Access Compliance Report

Public Rights-of-Way

(Curb Ramps)

Intersection ID: N/A	Main Street: PINEVILLE-MATTHEWS_RD	Cross Street: COURTSIDE_LN	Location: SW
ADA ID: 6A4BC24669F8	Ramp Type: Perp	Initial Pass/Fail: Fail	Overall Compliance: No
Codes/Mitigation Info/Possible Solution			Severity Score: 25
			Field Measurements/Component Compliance

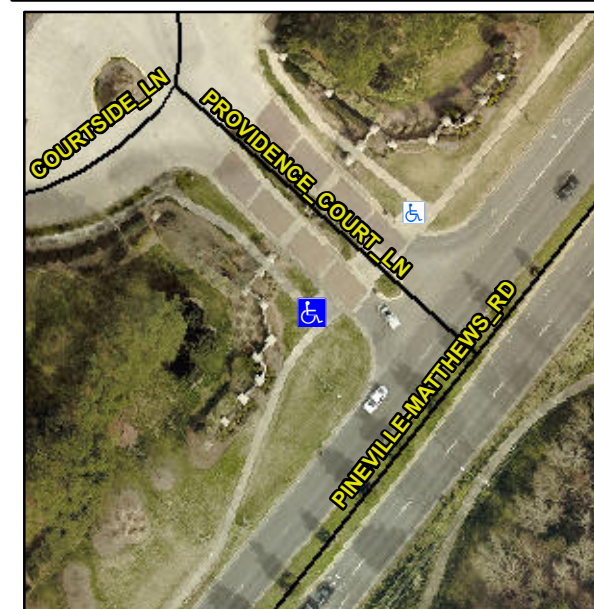
Not Found, R304.2.2

Compliance	Description	Data	Compliance	Description	Data
N/A	Ramp Length (in)	105.0	No	Ramp Slope (%)	12.3
Yes	Ramp Width (in)	56.0	Yes	Ramp XSlope (%)	1.0
N/A	Flare Type LT	N/A	N/A	Flare Type RT	N/A
N/A	Flare Slope LT (%)	N/A	N/A	Flare Slope RT (%)	N/A
N/A	Flare Traversable LT?	N/A	N/A	Flare Traversable RT?	N/A
N/A	Landing Length (in)	N/A	N/A	DWS Provided?	N/A
N/A	Landing Width (in)	N/A	N/A	DWS Contrast?	N/A
N/A	Landing Slope (%)	N/A	N/A	DWS Length (in)	N/A
N/A	Landing X Slope (%)	N/A	N/A	DWS Full Width?	N/A
N/A	Landing Curb? (Y/N)	N/A	N/A	DWS Offset (in)	N/A
N/A	Shared Landing?	N/A			
N/A	Gutter Ponding?	N/A	N/A	Gutter Slope (%)	N/A
N/A	Gutter Lip Ht (in)	N/A	N/A	Gutter X Slope (%)	N/A
N/A	Painted X Walk1?	No	N/A	Painted X Walk2?	N/A
	X Walk 1 Direction	To NE		X Walk 2 Direction	N/A
N/A	X Walk 1 Width (in)	N/A	N/A	X Walk 2 Width (in)	N/A
	X Walk 1 Slope (%)	1.5		X Walk 2 Slope (%)	N/A
	X Walk 1 X Slope (%)	1.8		X Walk 2 X Slope (%)	N/A

Remove & Replace Entire Ramp.
